Accessibility Survey

City of Glendale

Downtown Parking Lot #6

Inspected January 2008

Accessible Parking

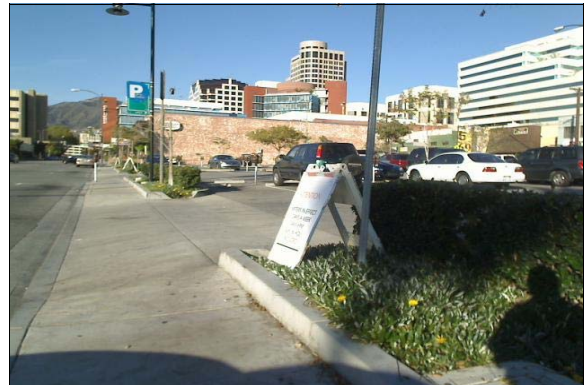
Finding: The surface of the accessible parking spaces has slopes greater than 2%.

Full Rec: Pave the parking lot at the accessible spaces to provide a level surface. Parking surfaces and access aisles shall be located in areas not exceeding 2% slope in all directions (see CBC 1129B and ADAAG 4.6.3).
